CAMPUS WIDE, REPLACEMENT/REHAB SAN SEWER SYSTEM CAT 5.5
South Dakota State University
Brookings, South Dakota
OSE# R0323--03X/ARPA
2024

ADDENDUM NO. 1

November 6, 2024

SHEET NO.
1110

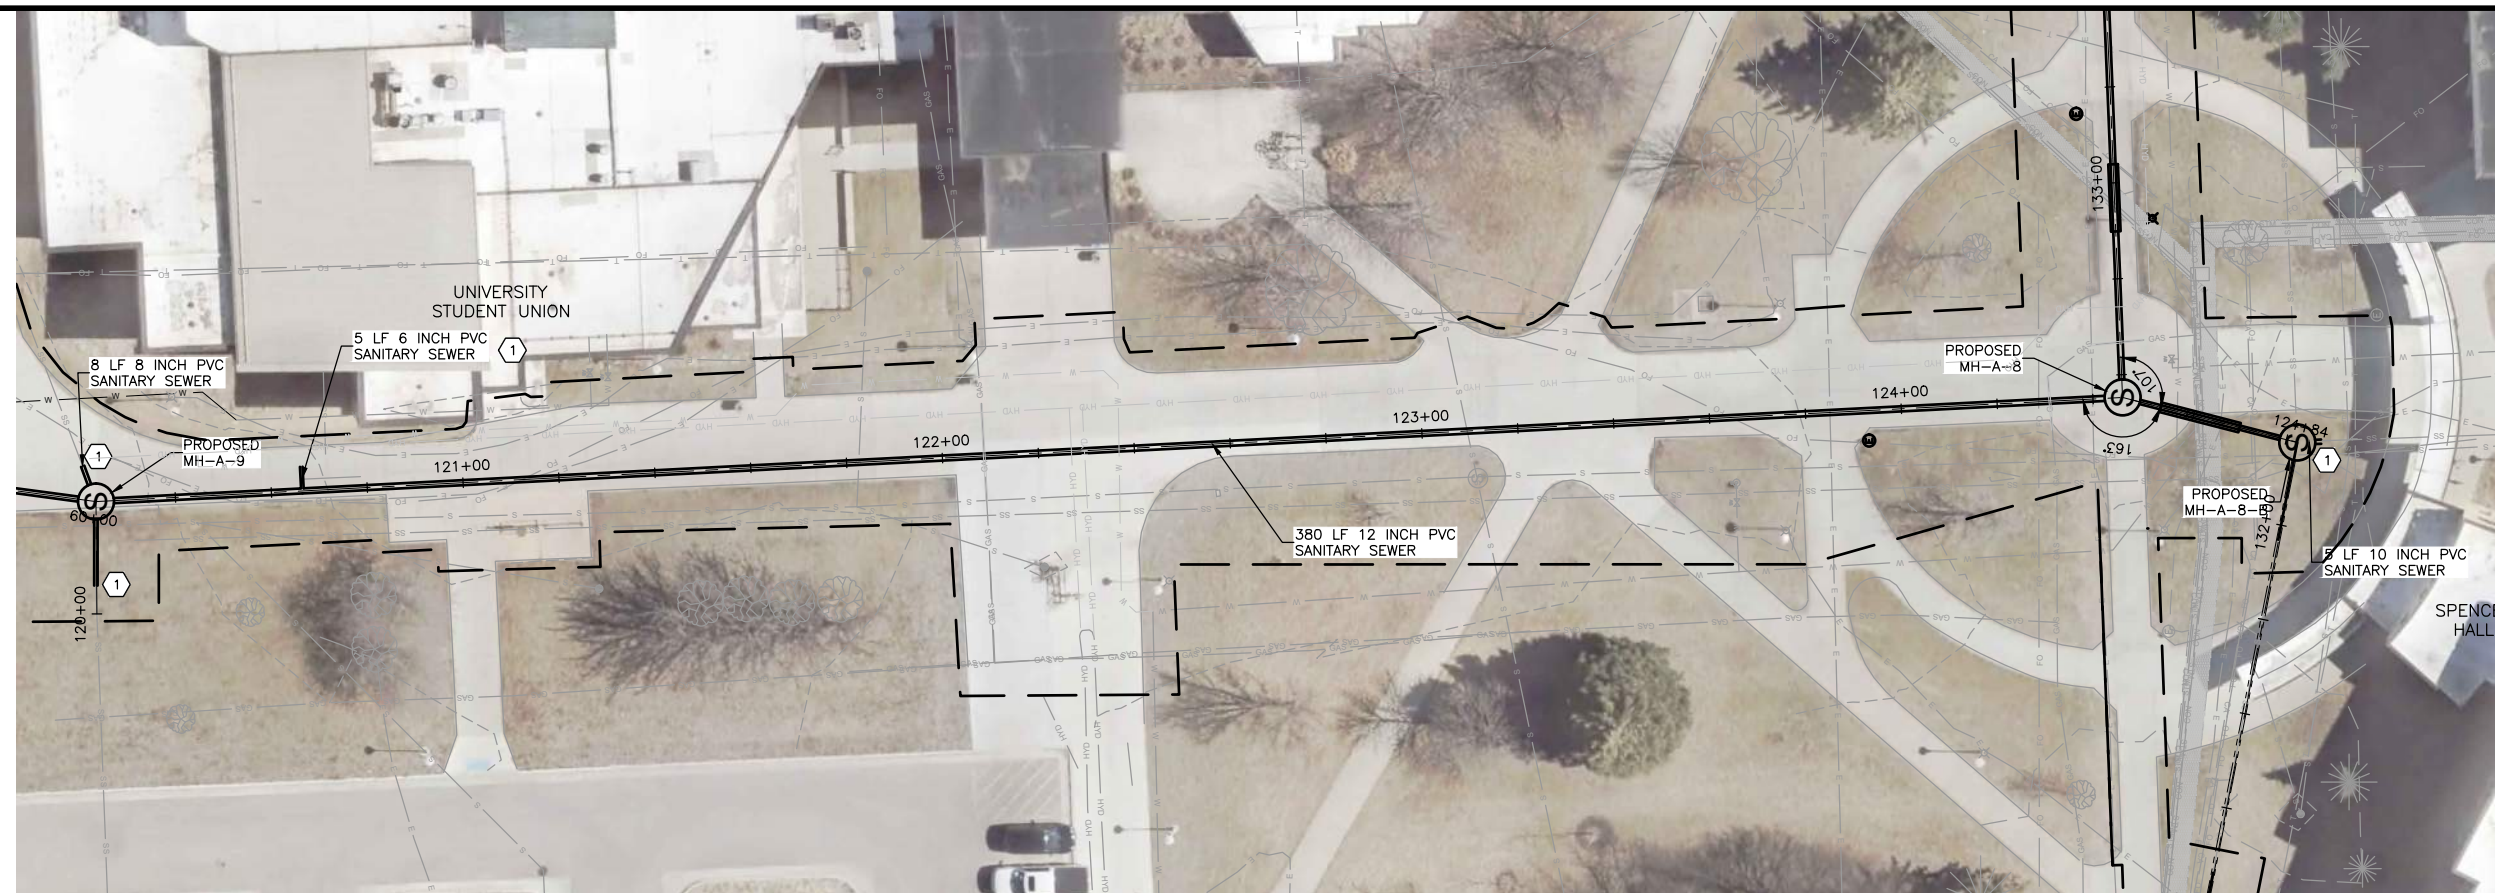
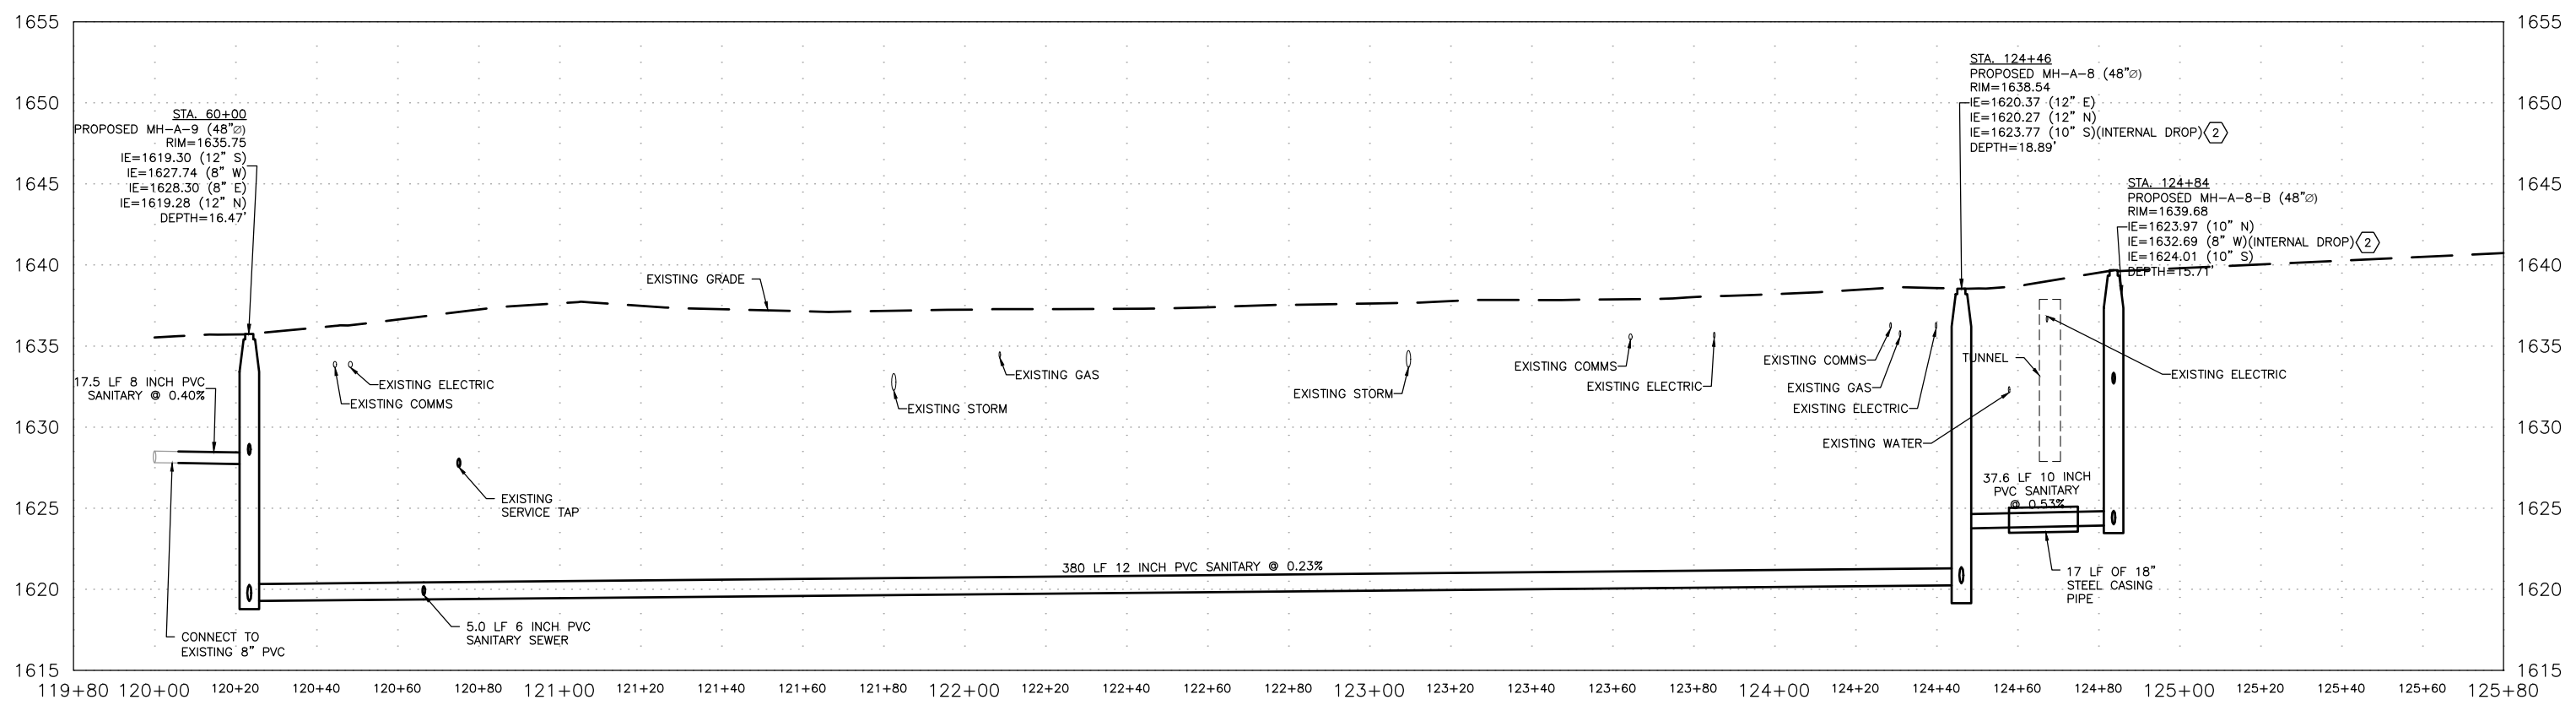
Modified call outs and keynotes.

SHEET NO.
1111

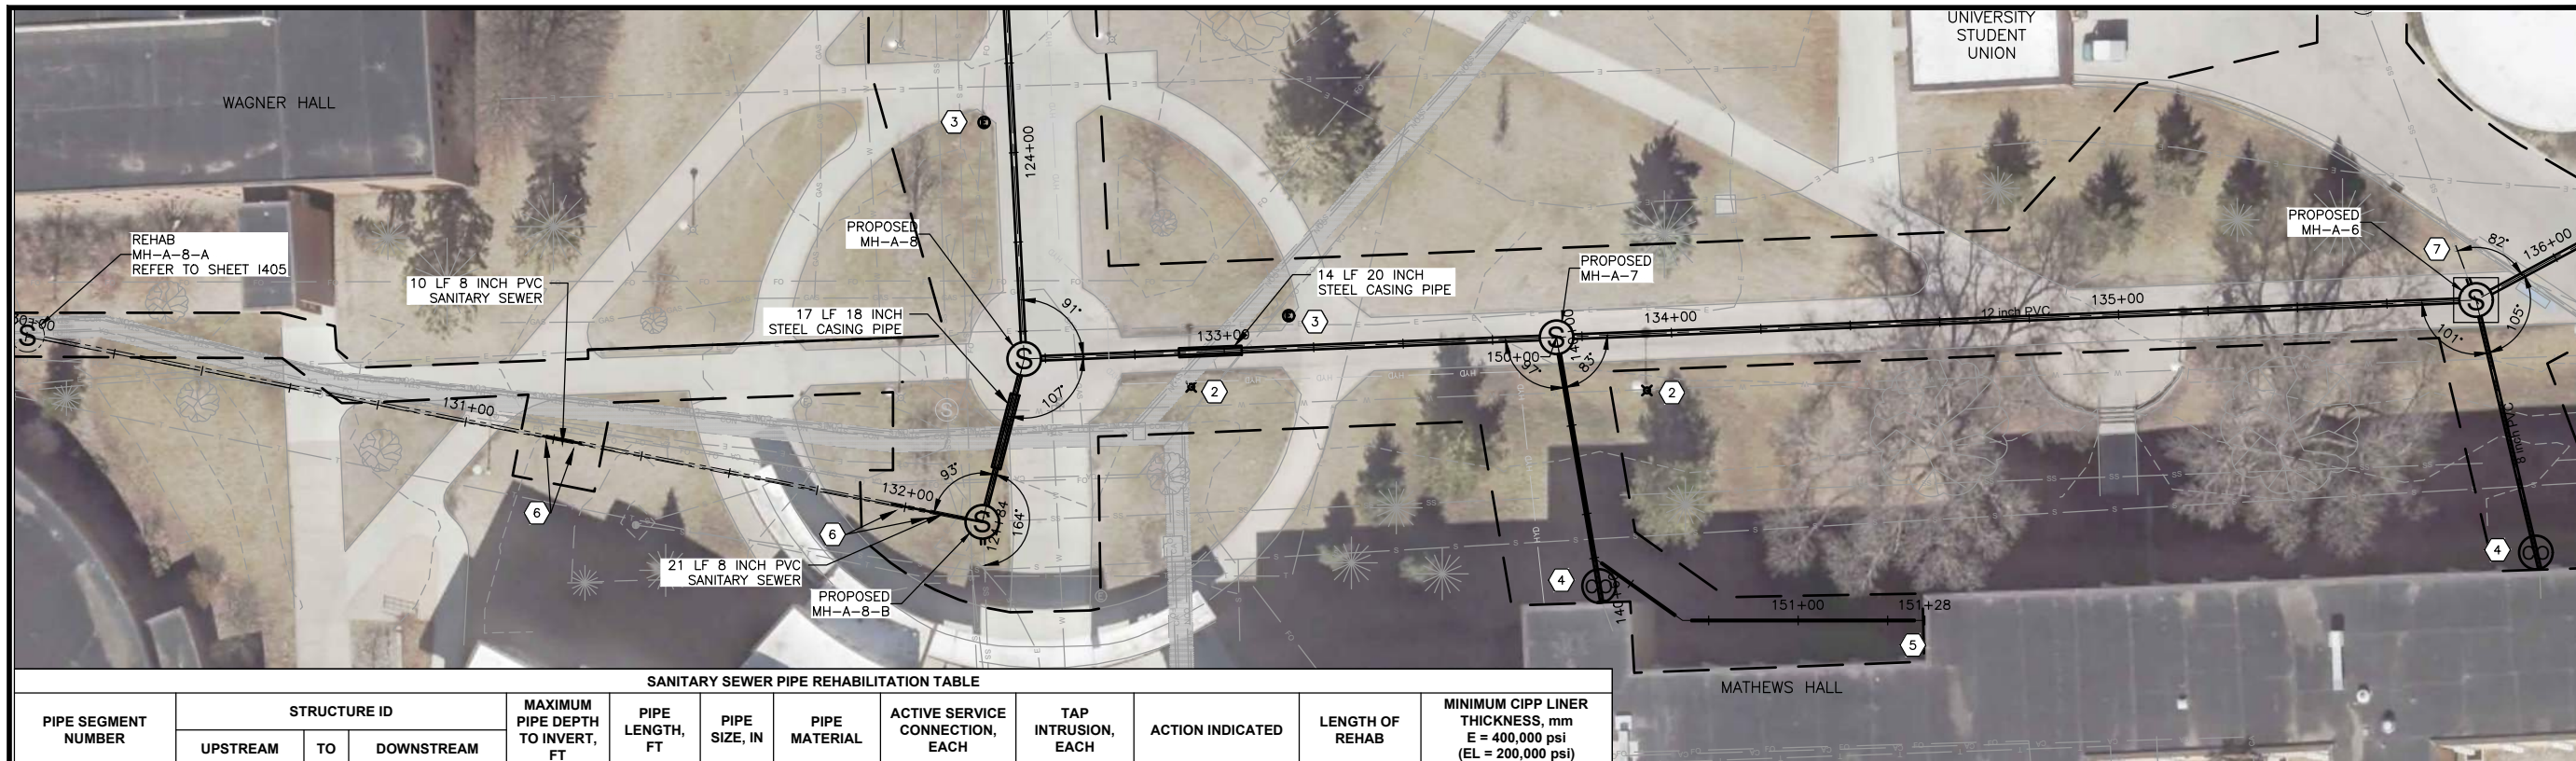
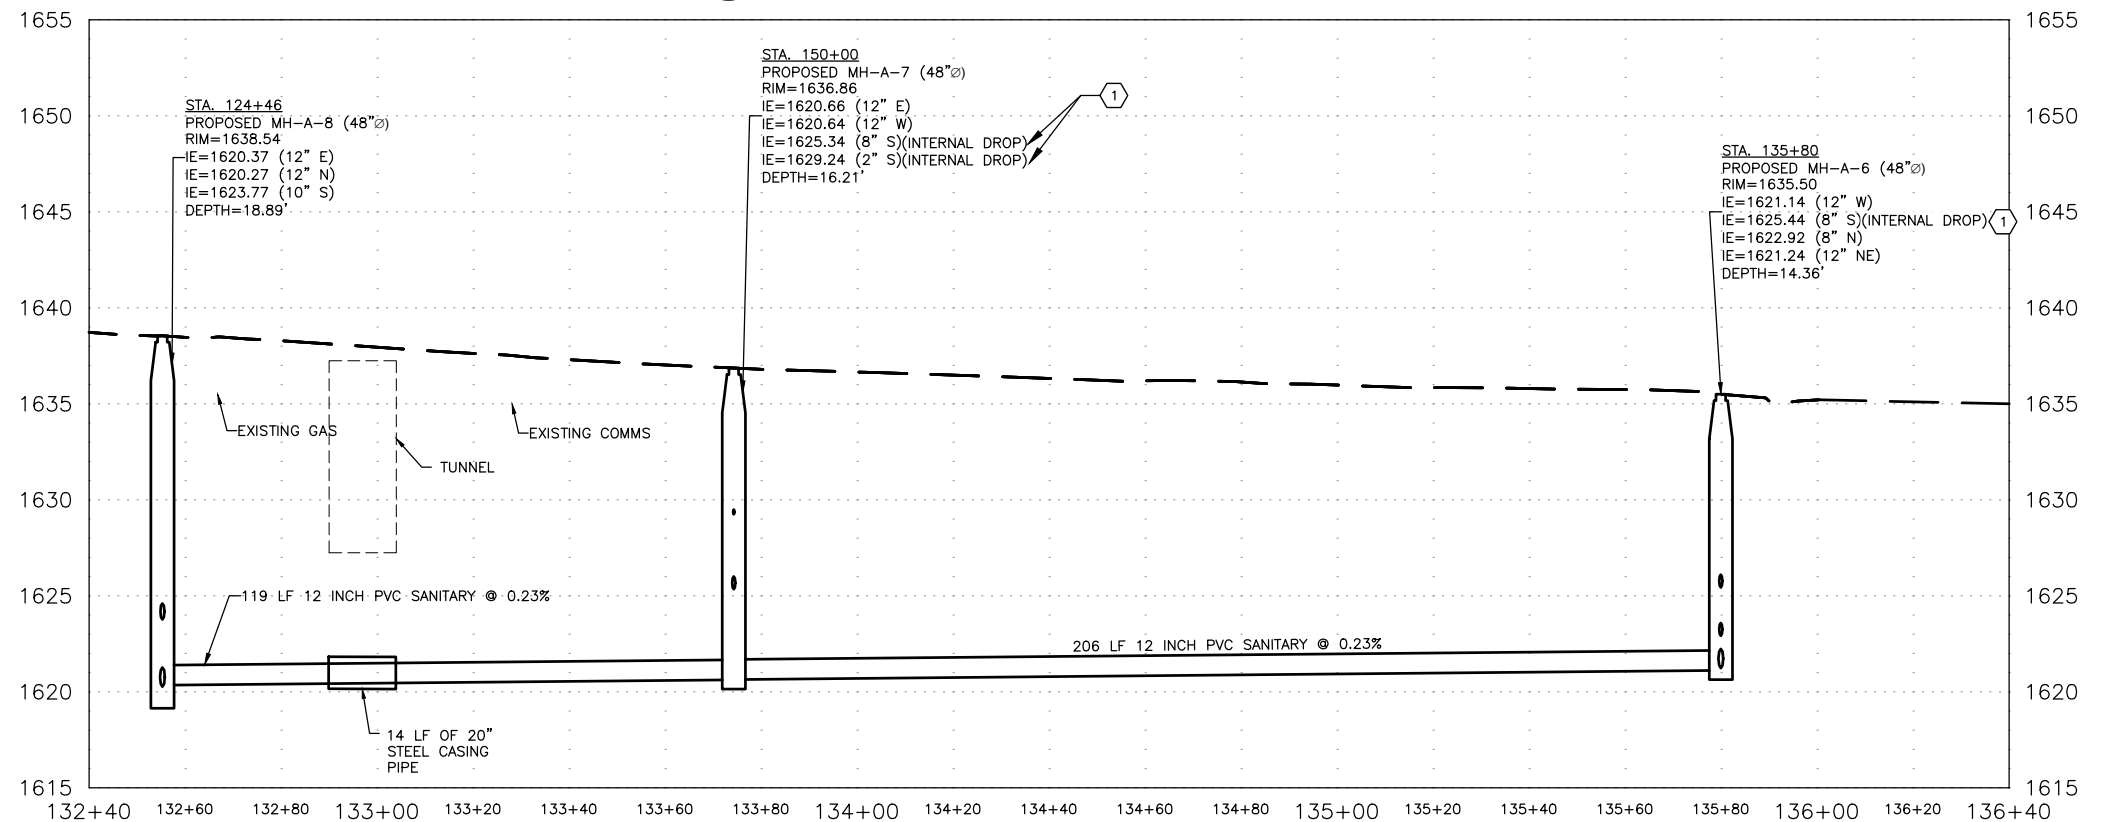
Modified call outs and keynotes.

SHEET NO.
1114

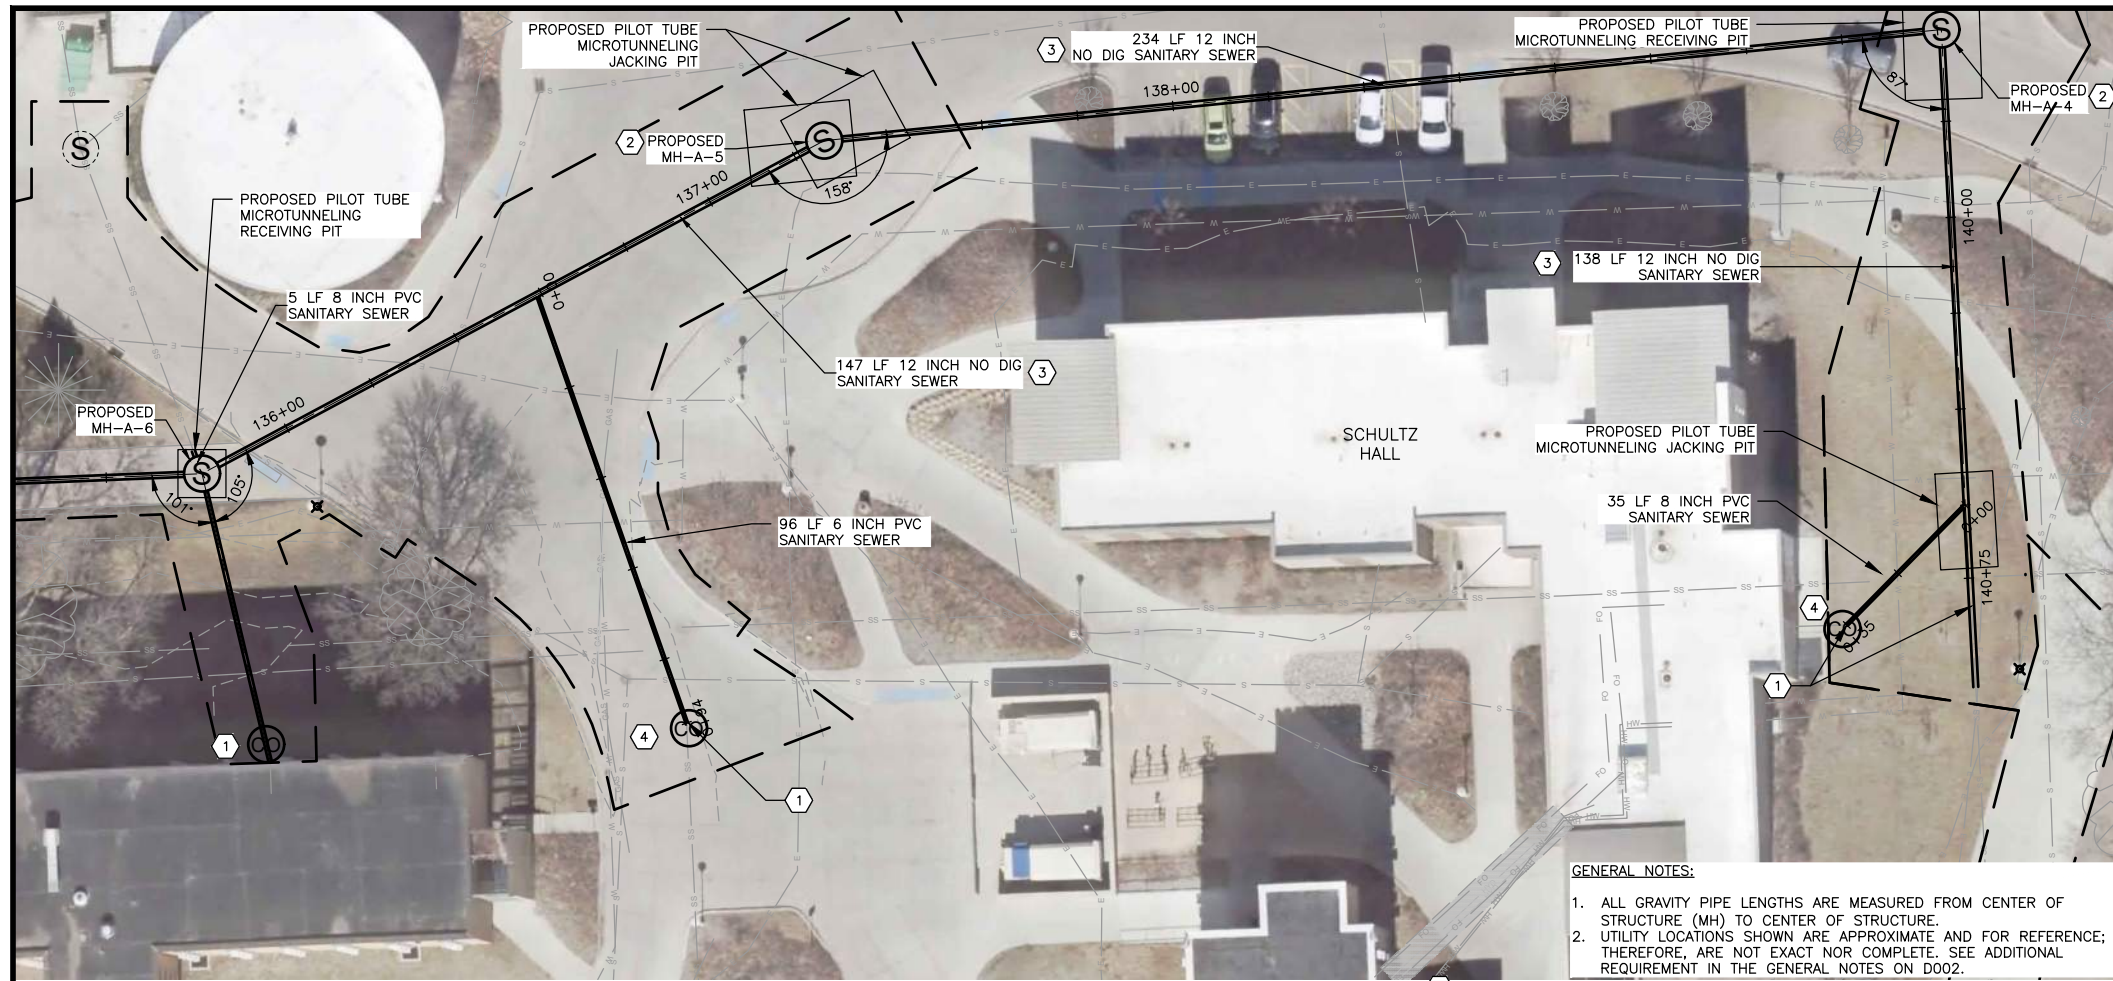
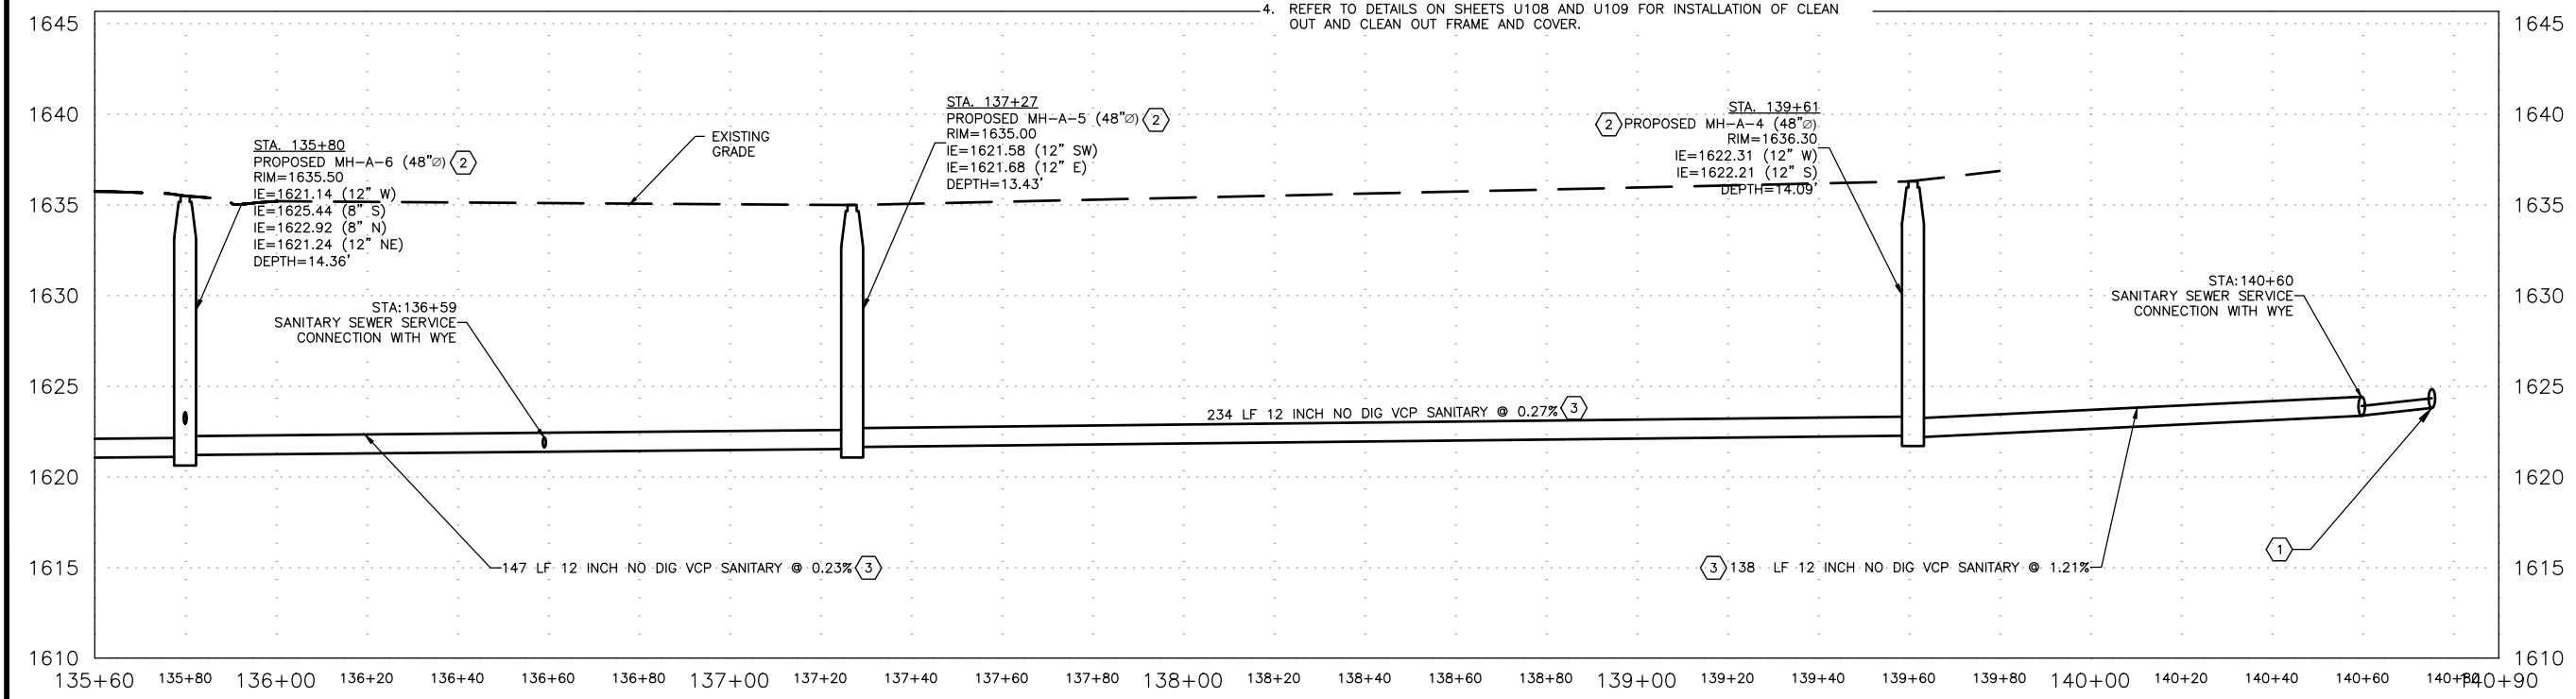
Modified call outs, keynotes, and general notes.
